Access Compliance Report

(Curb Ramps)

Intersection ID: 19204	Main Street: CHARTER_PL	Cross Street: ROCKY_FALLS_RD	Location: E
ADA ID: 349A050FA0FF	Ramp Type: BlendTrans1	Initial Pass/Fail: Fail	Overall Compliance: No
		Severity Score: 8.75

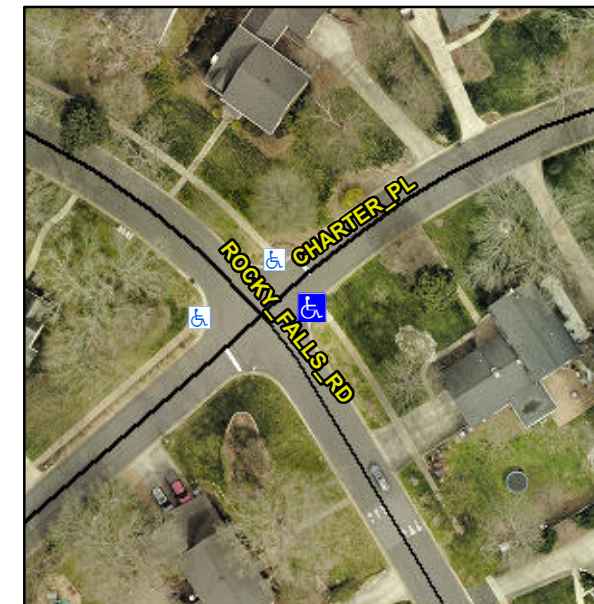
Not Found, R304.5.1

Compliance	Description	Data	Compliance	Description	Data
N/A	Ramp Length (in)	50.0	Yes	BlendTrans Slope (%)	3.9
No	Ramp Width (in)	44.0	Yes	BlendTrans XSlope (%)	0.5
N/A	Flare Type LT	N/A	N/A	Flare Type RT	N/A
N/A	Flare Slope LT (%)	N/A	N/A	Flare Slope RT (%)	N/A
N/A	Flare Traversable LT?	N/A	N/A	Flare Traversable RT?	N/A
N/A	Landing Length (in)	N/A	N/A	DWS Provided?	N/A
N/A	Landing Width (in)	N/A	N/A	DWS Contrast?	N/A
N/A	Landing Slope (%)	N/A	N/A	DWS Length (in)	N/A
N/A	Landing X Slope (%)	N/A	N/A	DWS Full Width?	N/A
N/A	Landing Curb? (Y/N)	N/A	N/A	DWS Offset (in)	N/A
N/A	Shared Landing?	N/A			
N/A	Gutter Ponding?	N/A	N/A	Gutter Slope (%)	N/A
N/A	Gutter Lip Ht (in)	N/A	N/A	Gutter X Slope (%)	N/A
N/A	Painted X Walk1?	No	N/A	Painted X Walk2?	No
	X Walk 1 Direction	To NW		X Walk 2 Direction	To SW
	X Walk 1 Width (in)	N/A		X Walk 2 Width (in)	N/A
	X Walk 1 Slope (%)	4.7		X Walk 2 Slope (%)	2.8
	X Walk 1 X Slope (%)	2.9		X Walk 2 X Slope (%)	5.8

N/A	Ramp inside XWalk1?	N/A	N/A	Ramp inside XWalk2?	N/A
	Road Slope (%)	0.2		Clear Space?	N/A
	Road X Slope (%)	5.6	N/A	Clear Space to XWalk (in)	N/A
N/A	Any Obstructions?	N/A	N/A	Storm Grate/Utility Hazard?	N/A
	Obstruction Type			Storm Grate/Utility Type	
		N/A			N/A
			Yes	Surface Condition? (G/P)	Good
			No	Curb Slope (%)	7.3

Remove & Replace Curb Ramp With Two New Directional Ramps or Equivalent.
